Woolworths Regional Distribution Centre

11 Warren Road, Warnervale
NSW 2259

Access Review – DA 3 (Final)

24 March 2022

TITLE:
PROPOSED TRUCK WASH AND
MAINTENANCE FACILITY

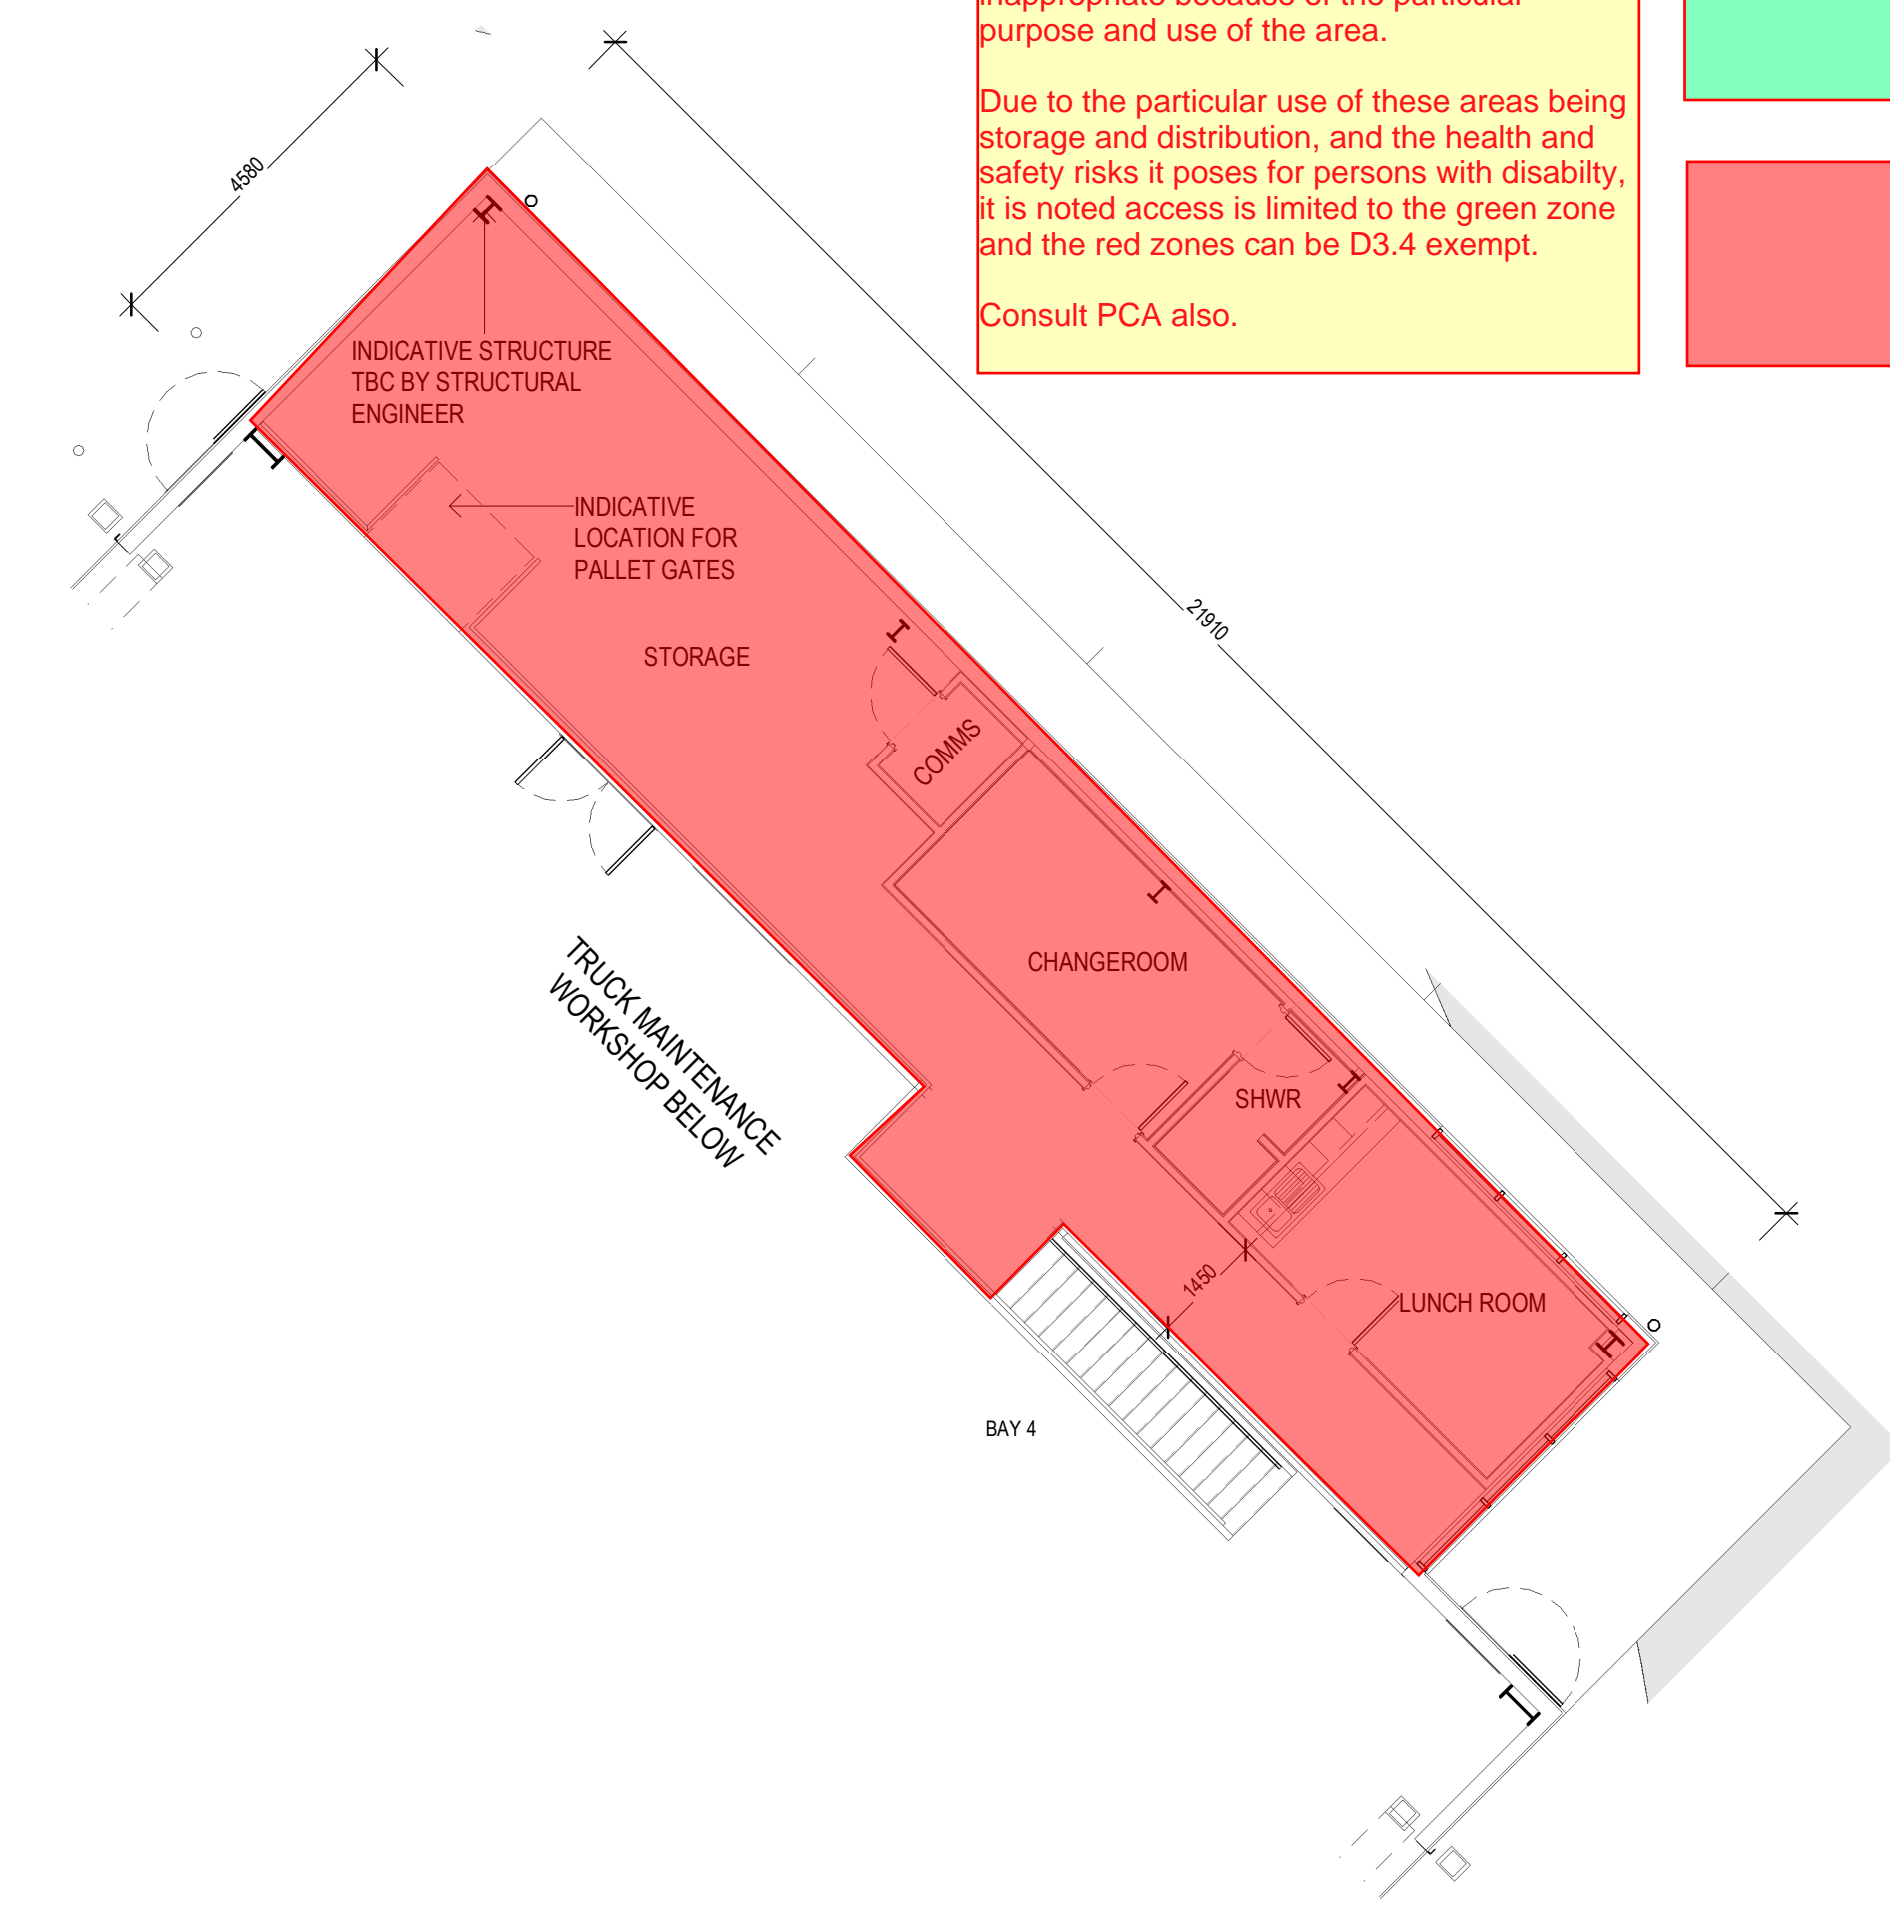
Areas not required to be accessible.
BCA D3.4 Exemption is applicable for areas that poses the health and safety risks for persons with disability, or where access is inappropriate because of the particular purpose and use of the area.
Due to the particular use of these areas being storage and distribution, and the health and safety risks it poses for persons with disability, it is noted access is limited to the green zone and the red zones can be D3.4 exempt.
Consult PCA also.

fully accessible areas for staff visitors would need to be escorted in these areas

non-accessible - unsafe work environment / no safe paths of travel

PROPOSED FLOOR PLAN - AMBIENT
SCALE: 1 : 500

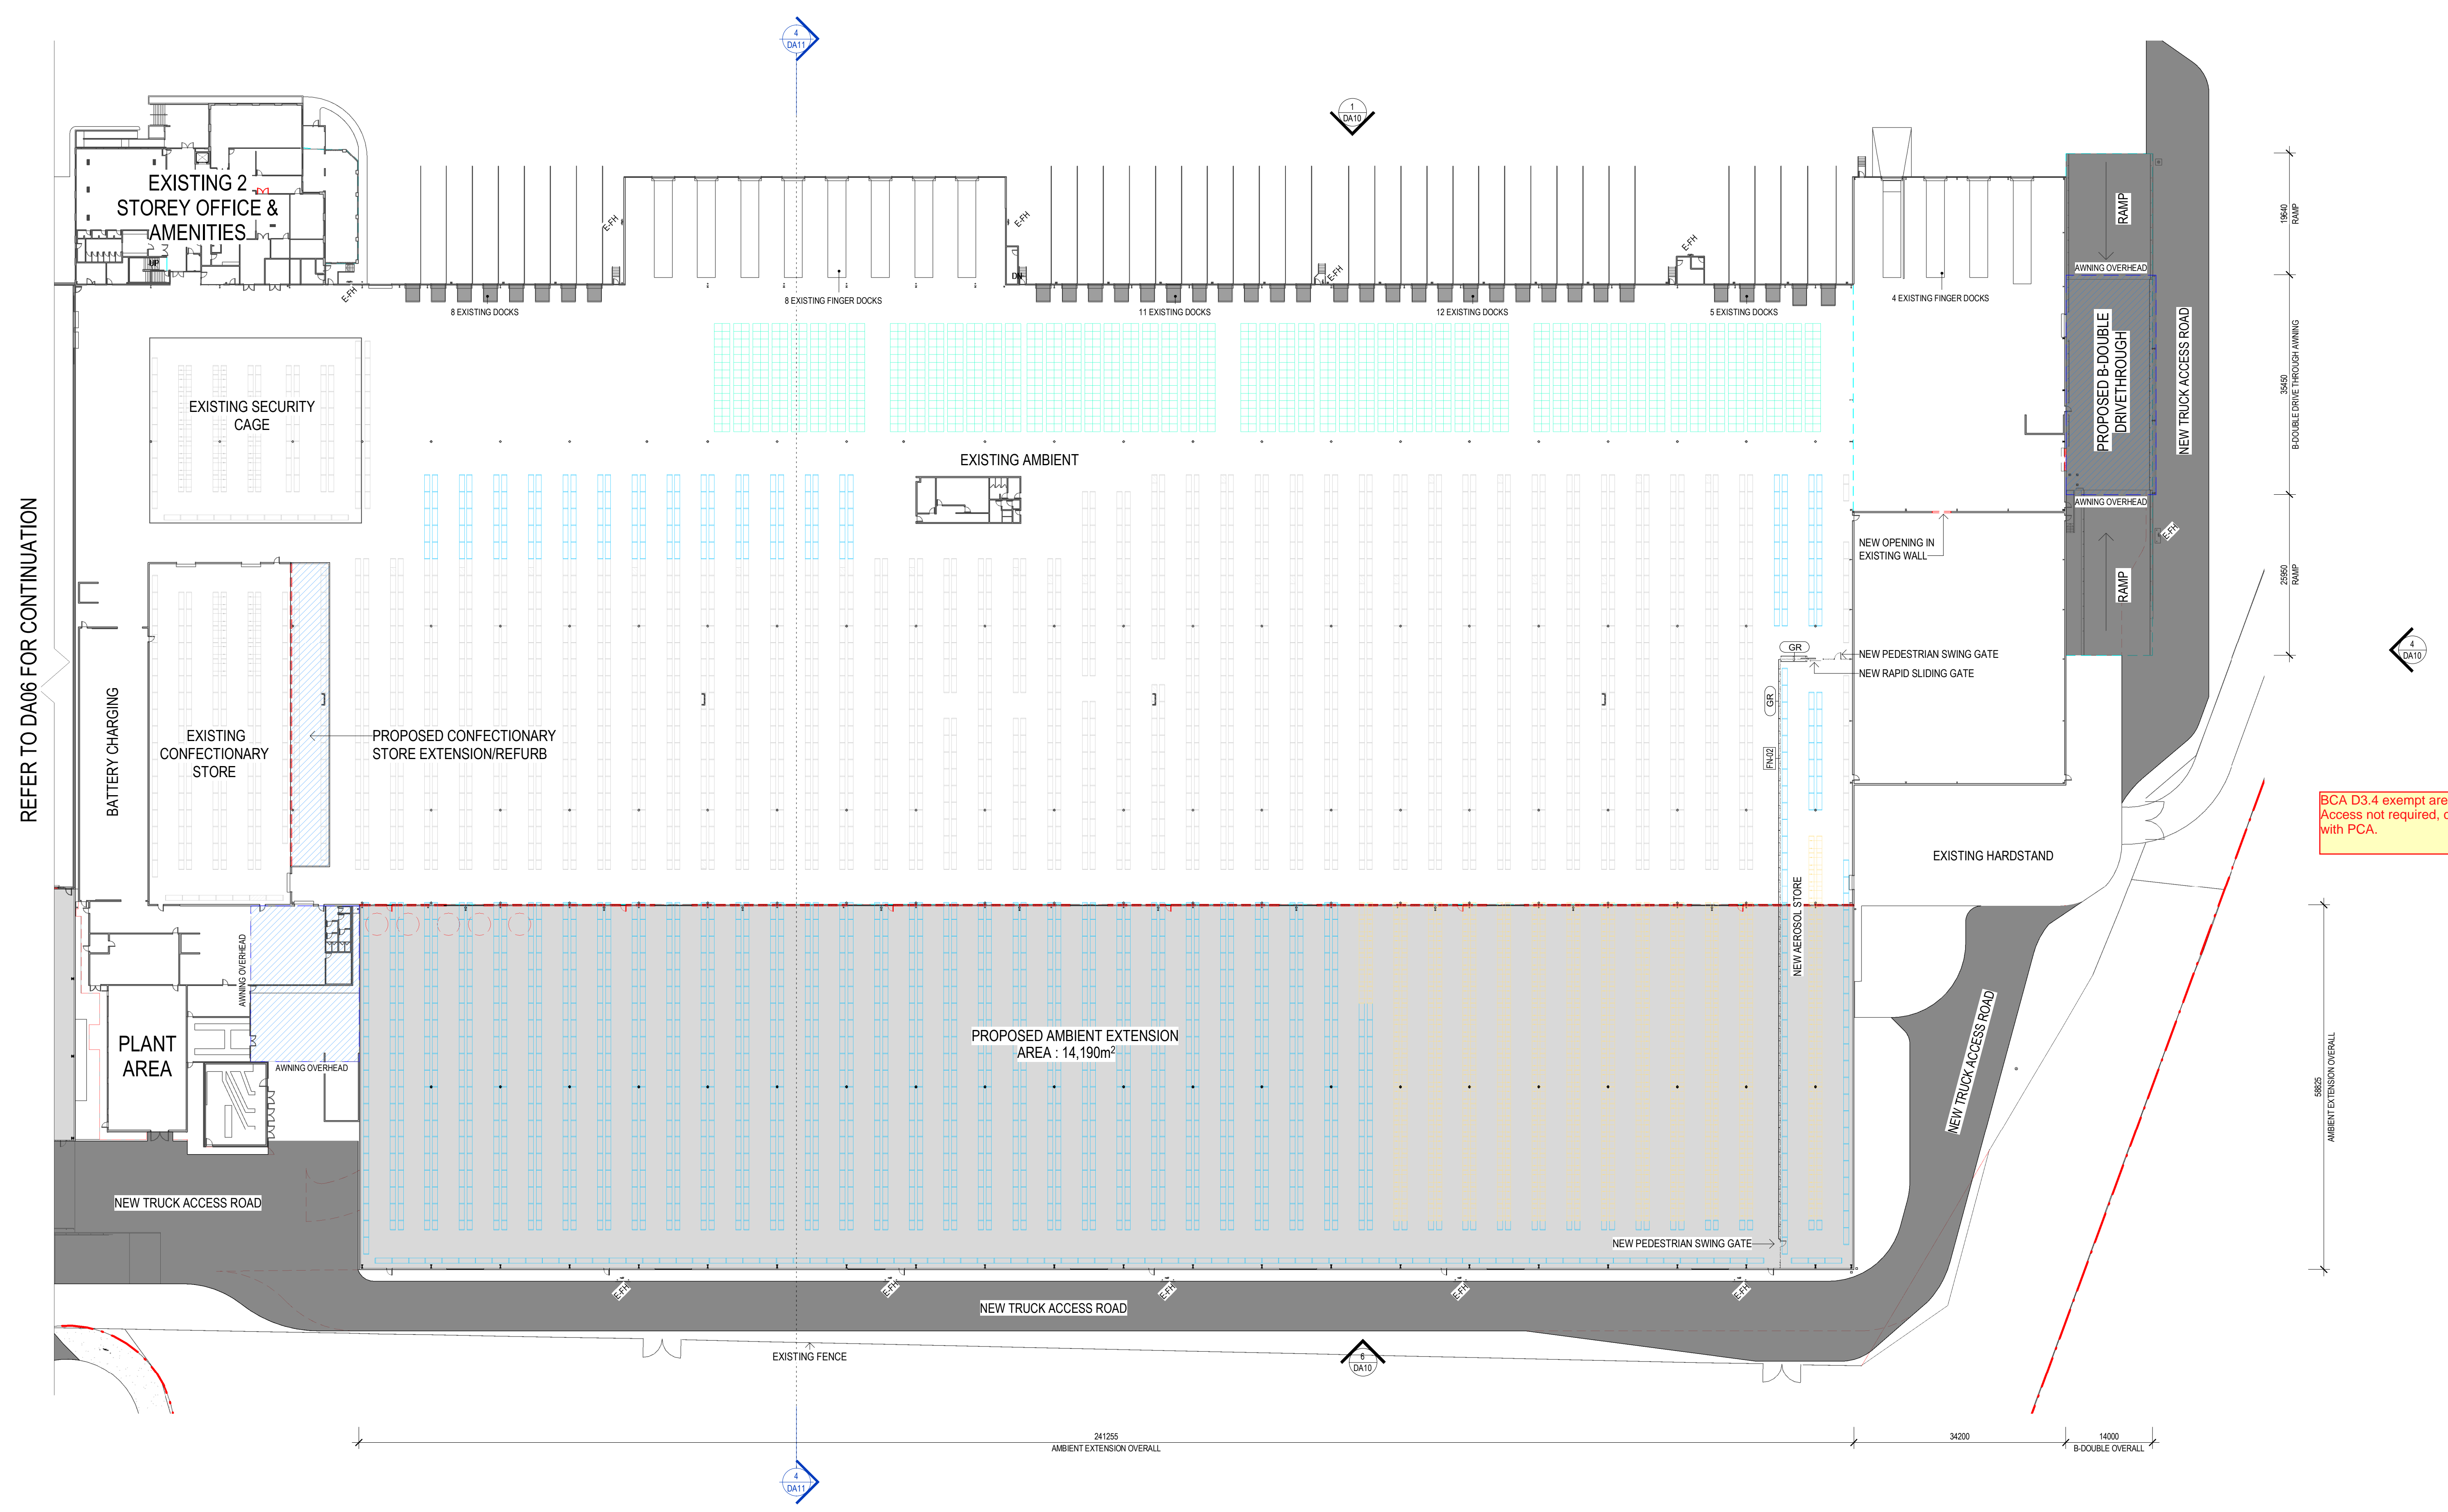
BCA D3.4 exempt areas. Access not required, confirm with PCA.

TITLE: MAIN OFFICE & AMENITIES
 FLOOR PLAN - LEVEL 1

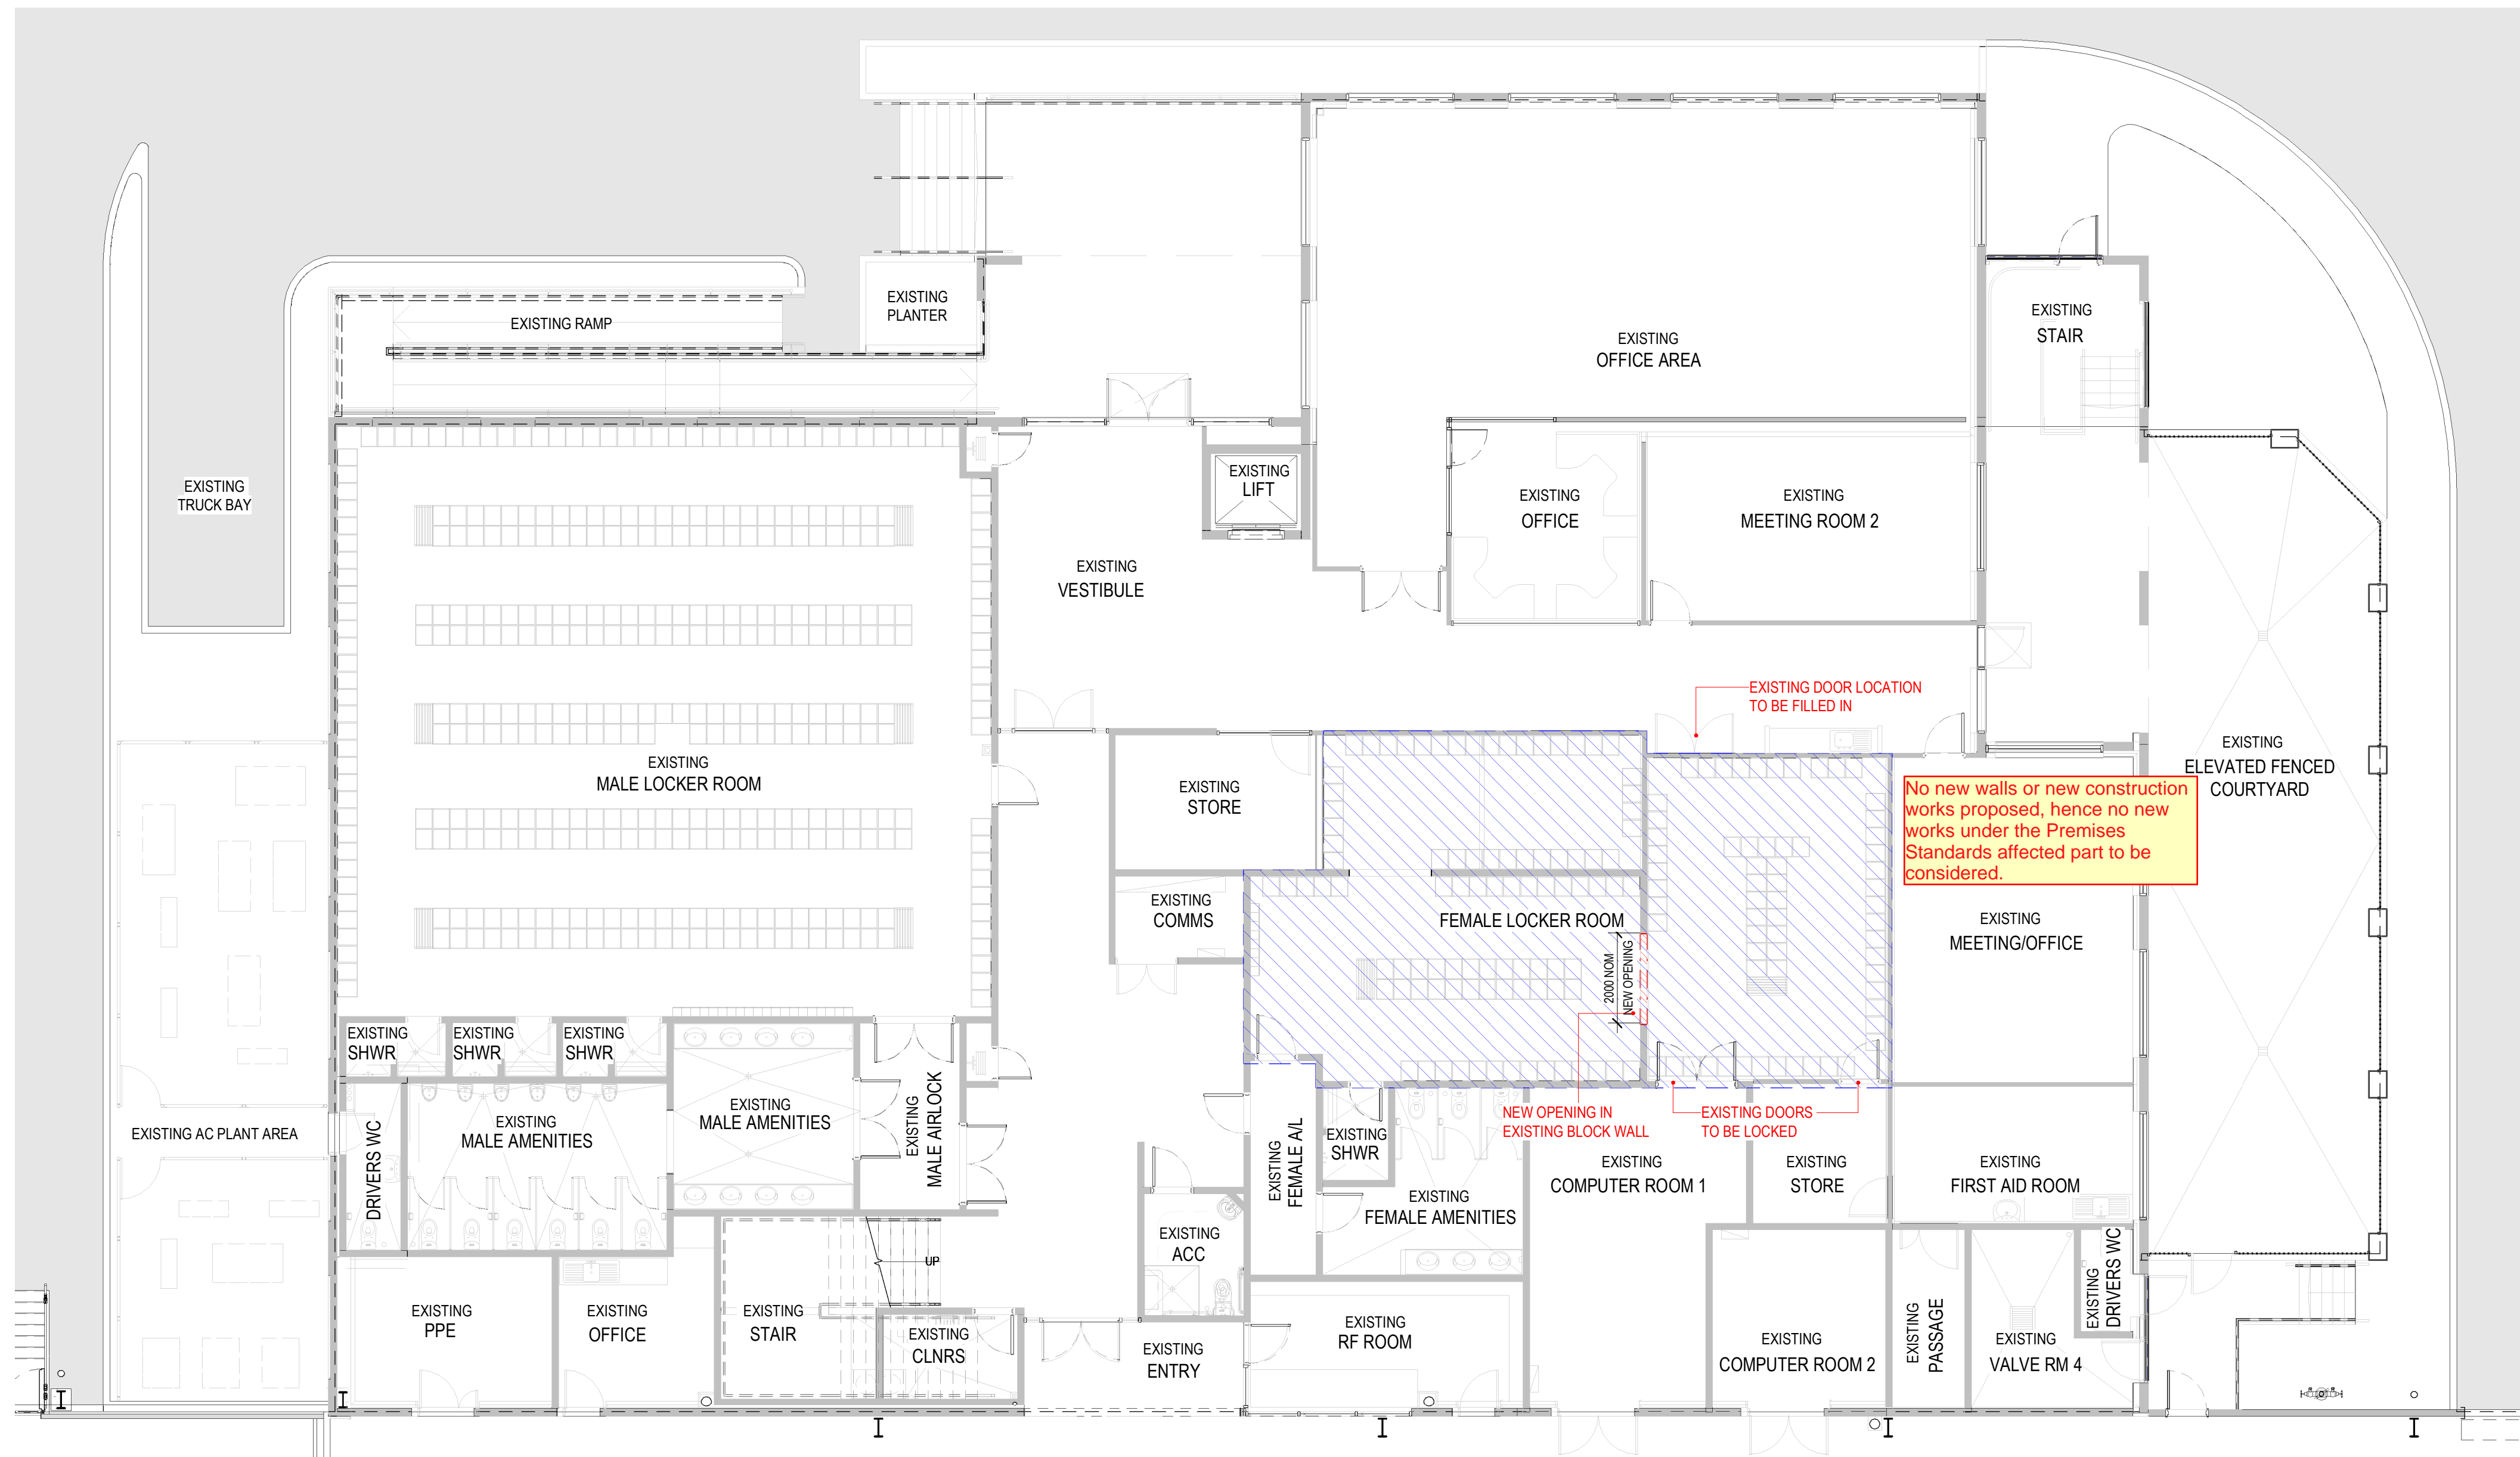
No new walls or new construction works proposed, hence no new works under the Premises Standards affected part to be considered.
